EA Project No.: 15-2100

DATE OF ADDENDUM ISSUANCE: Monday, February 1, 2016

The Project Manual and Drawings dated January 15, 2016 for the above referenced project are hereby amended as follows:

PARK MIDDLE SCHOOL ADDITION

CD001

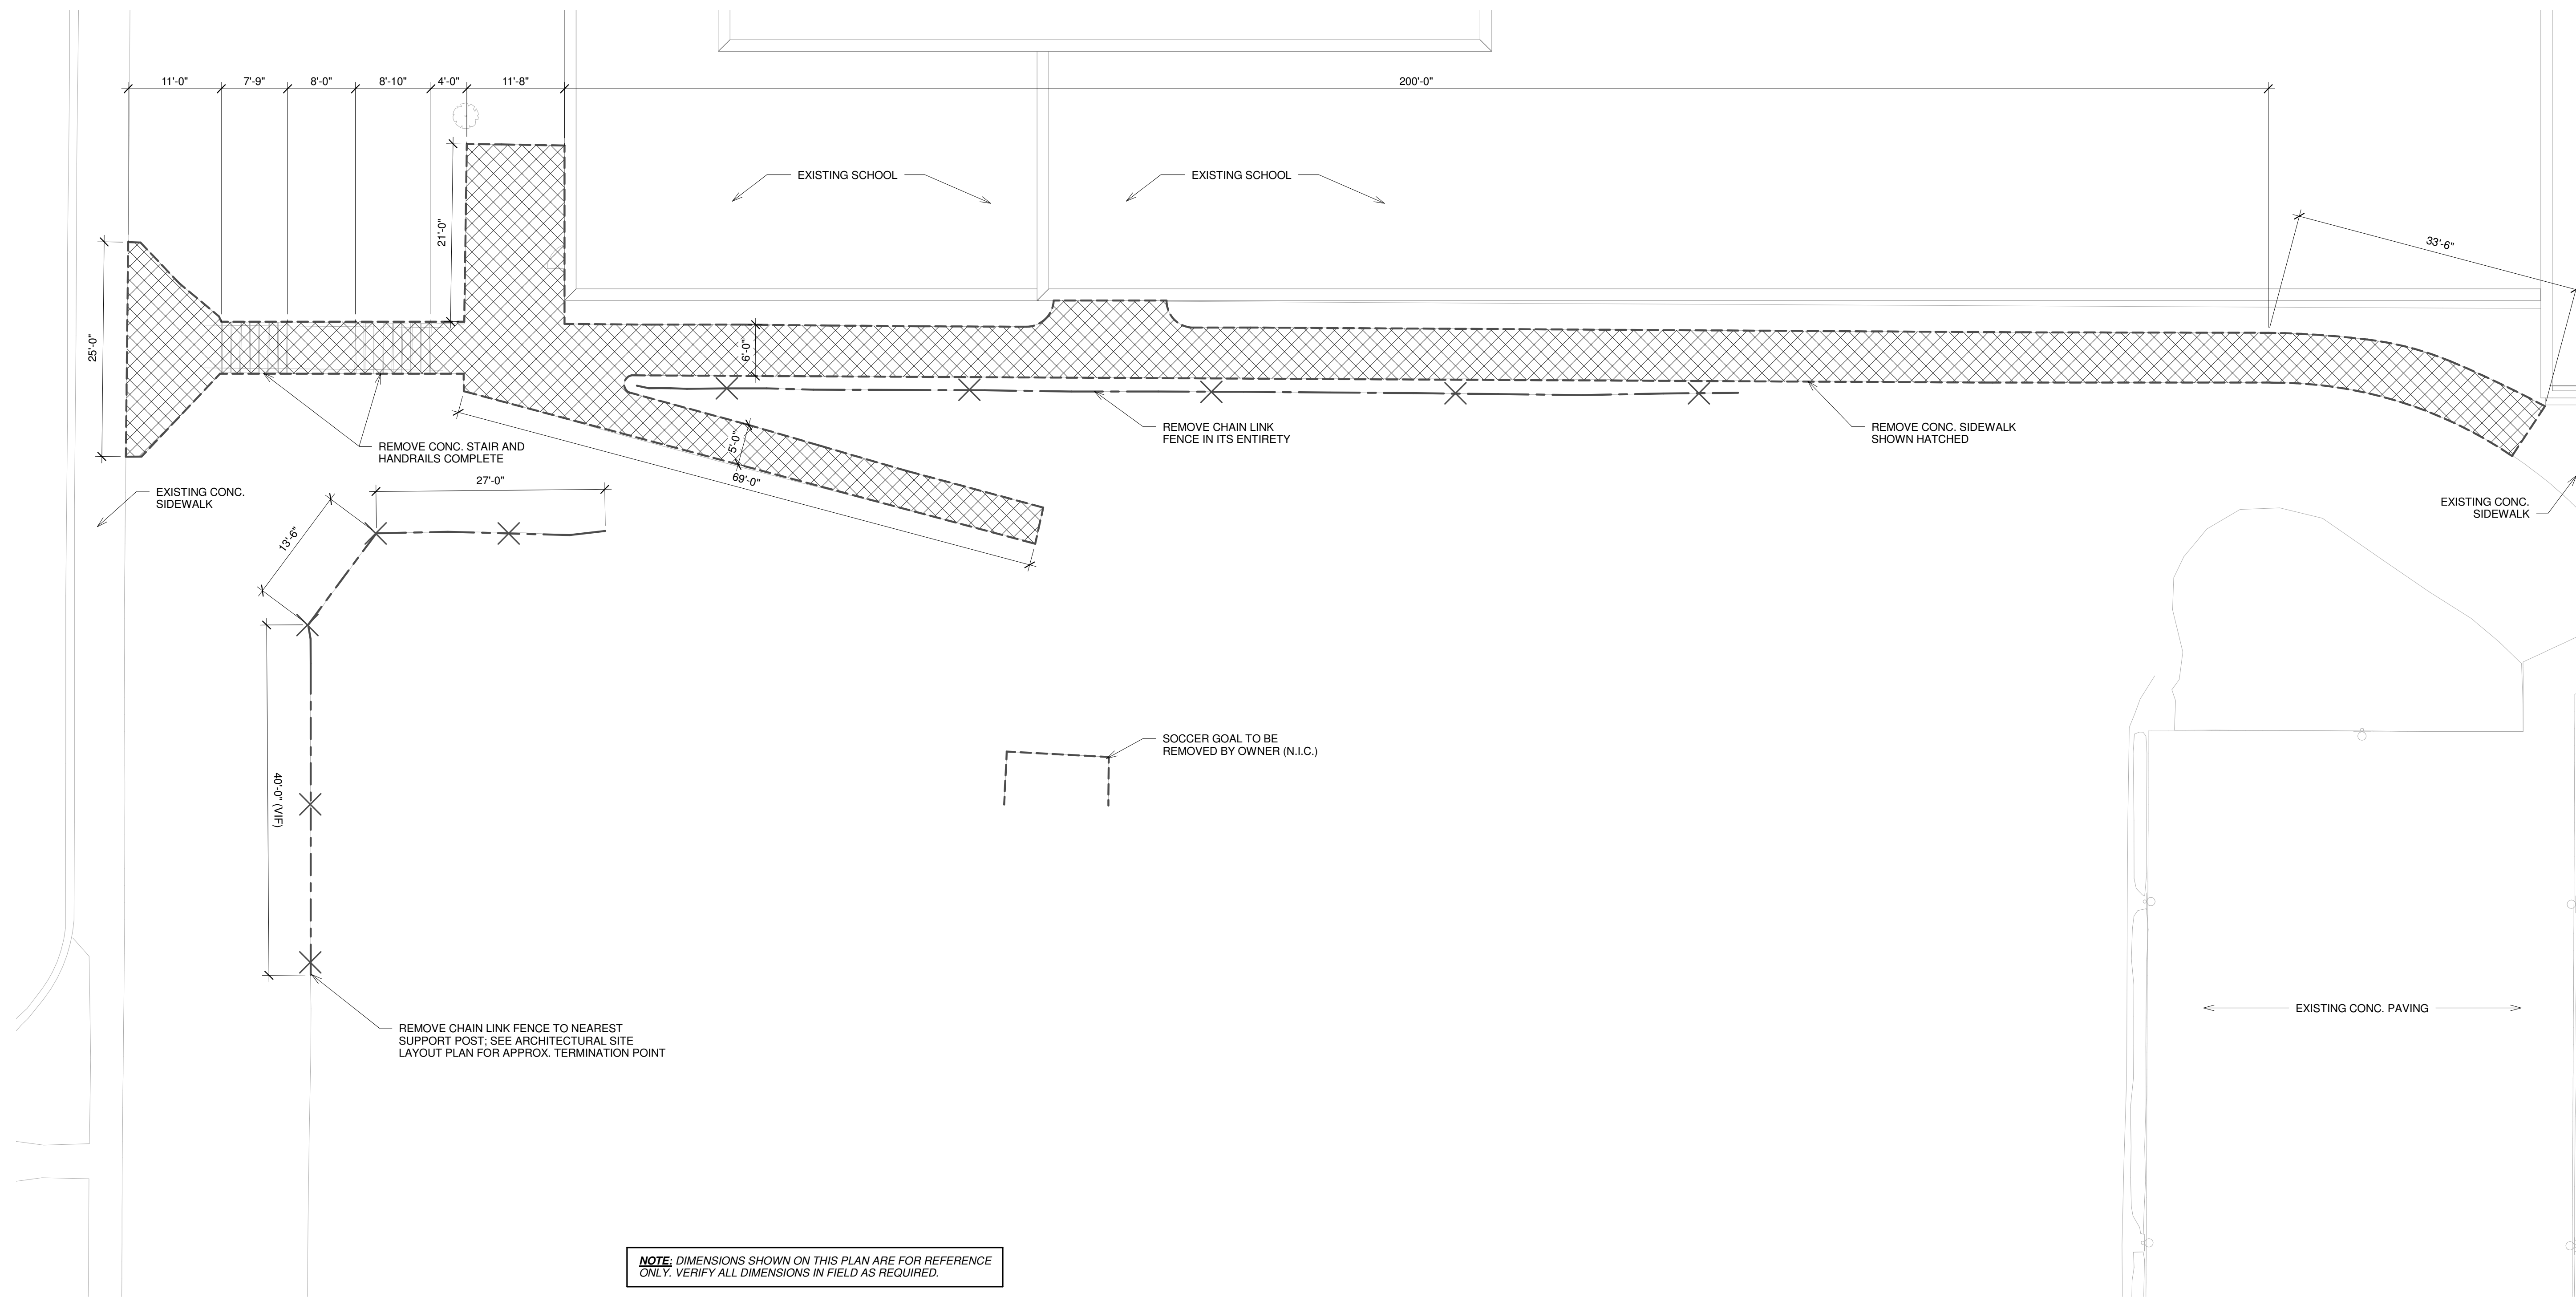
Modification	Sheet Affected
1. Addendum Item AD-4: Section 042000 – Unit Masonry	--
2. CD001 – Site Demolition Plan	CD001
3. AC101 – Architectural Site Layout Plan and Details	AC101
4. ASK01 – Remove Aluminum Storefront Windows	AD002
5. ASK02 – Updated Grille Locations / New ACT Ceiling	A201
6. ASK03 – Revised Window Type ‘H’ / Added Fire-Rated Wall	A504
7. ASK04 – Added Detail 18	A506
8. ASK05 – Revise Window Type ‘H’	A601

ASK01

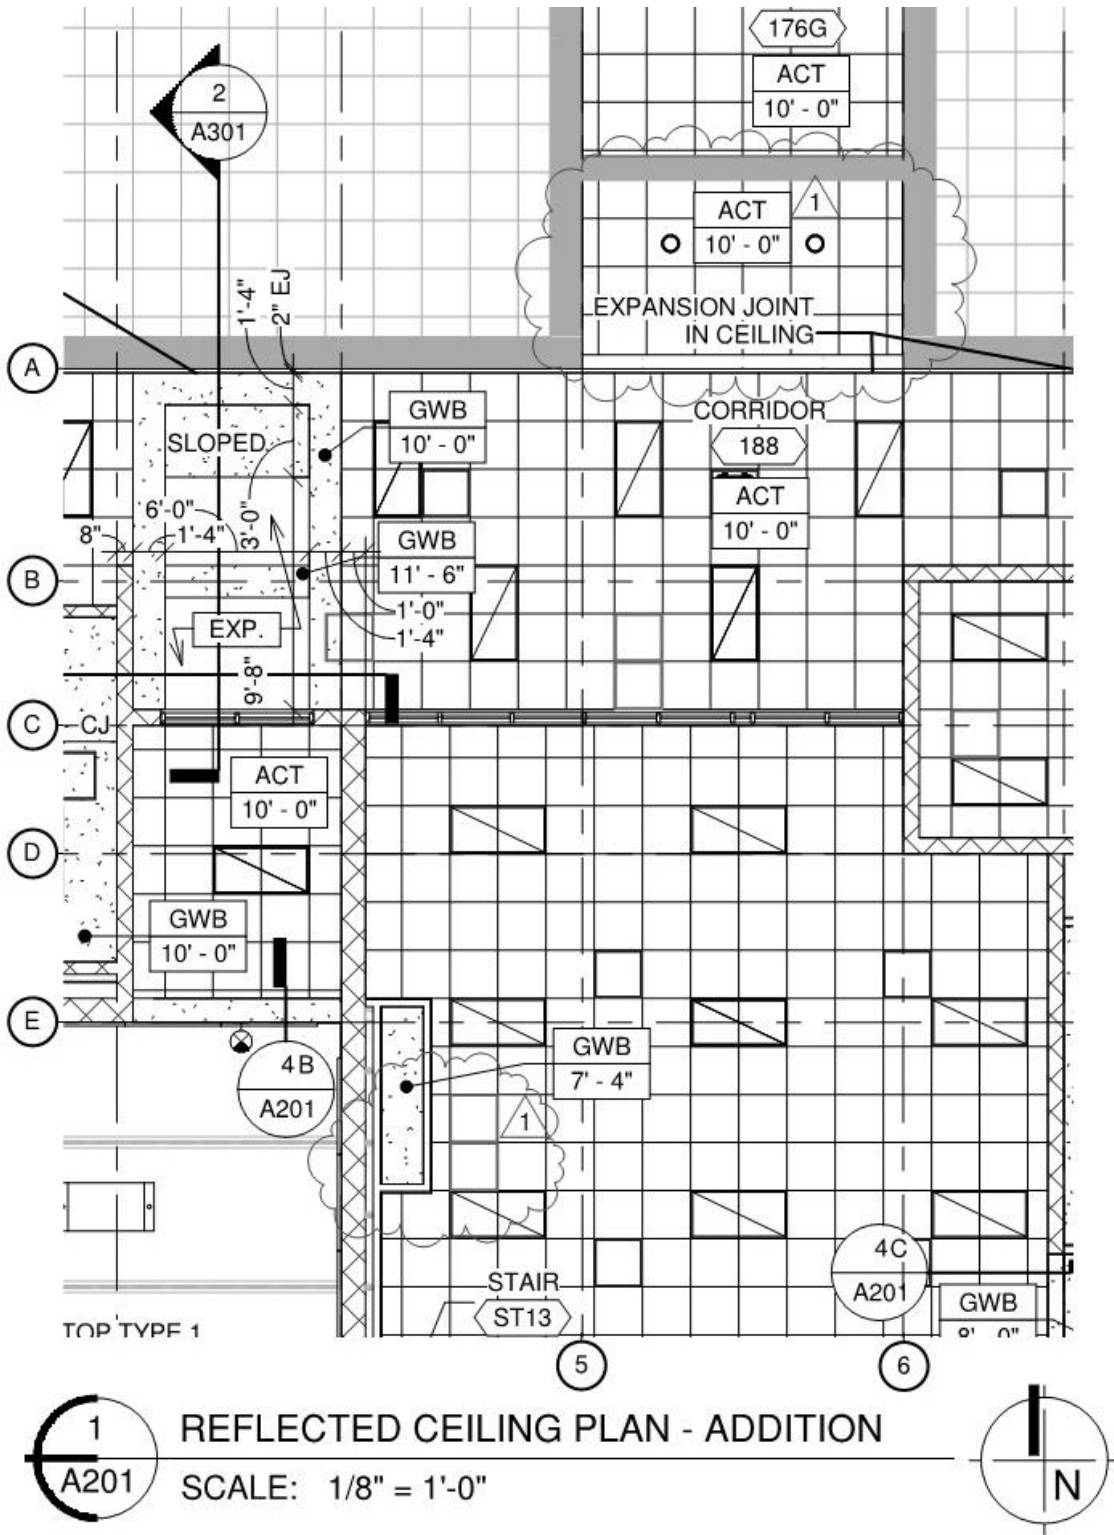
Revision : 1
To Sheet: AD002
Issue Date: 01 FEB 2016
Reference: ADDENDUM NO. 1
REMOVE ALUM. STOREFRONT WINDOWS

ASK02

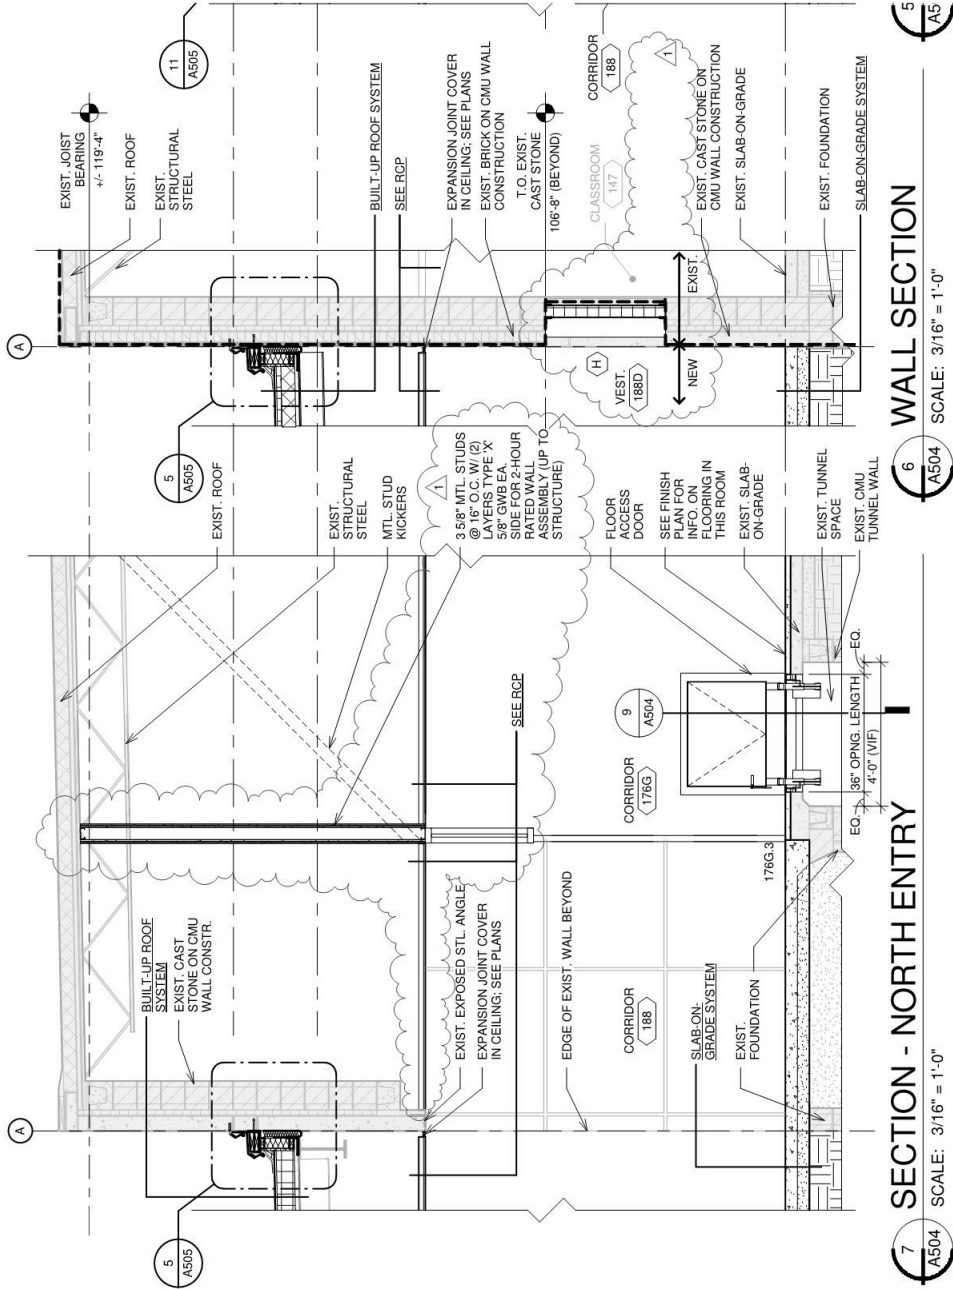
UPDATED GRILLE
 LOCATIONS / ADDED
 ACT CEILING

Revision : 1
To Sheet: A504

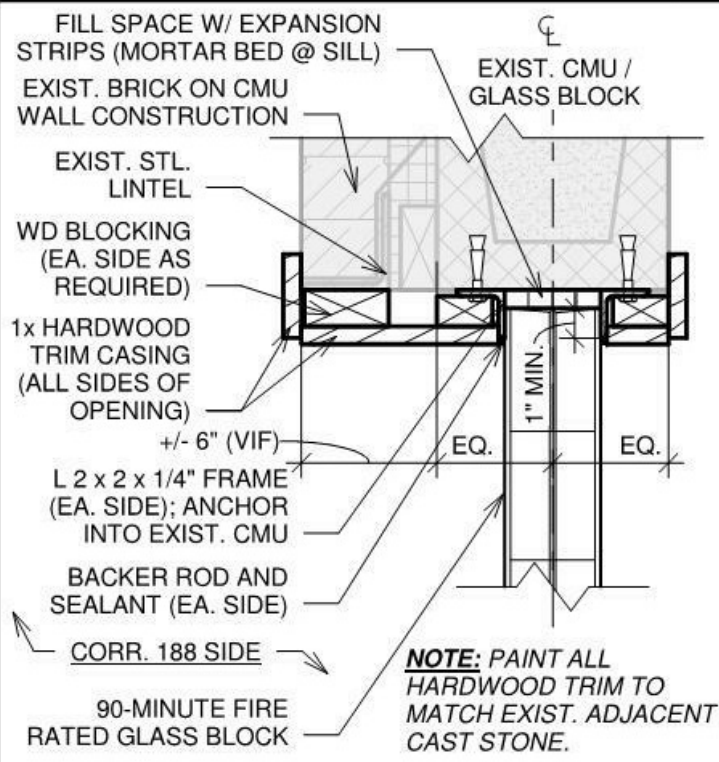
REVISE WINDOW TYPE
'H'

ASK04

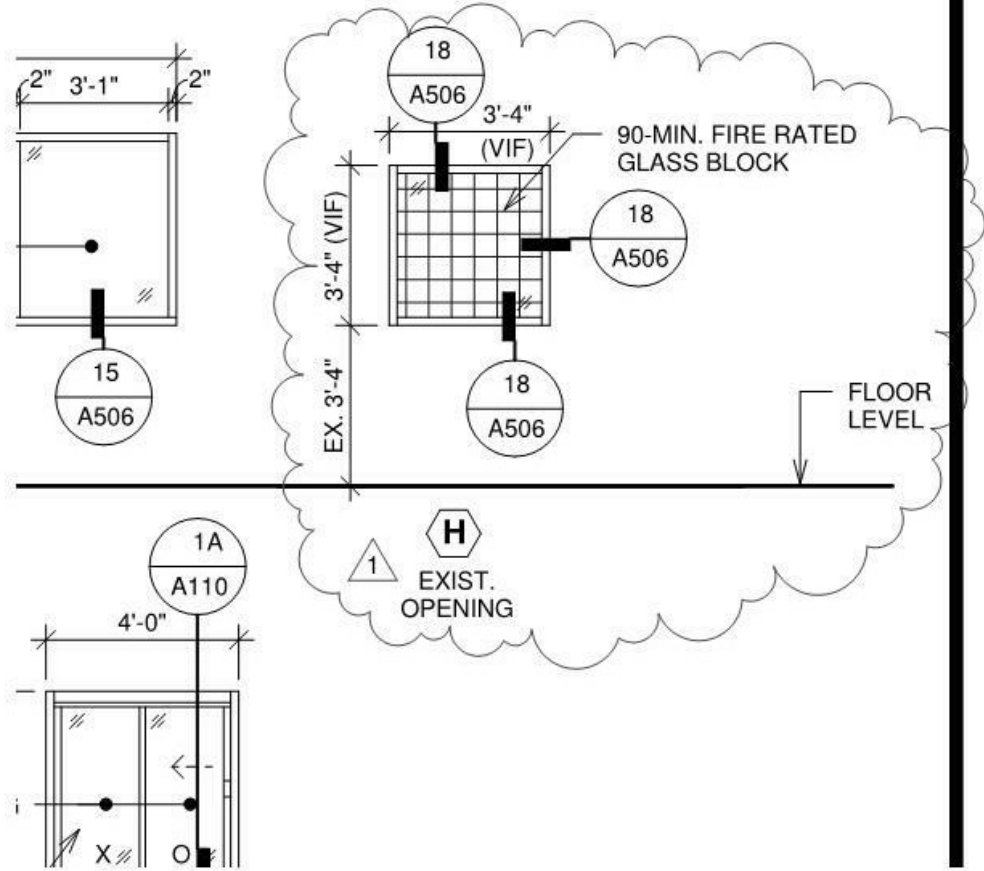
ADDED DETAIL 18
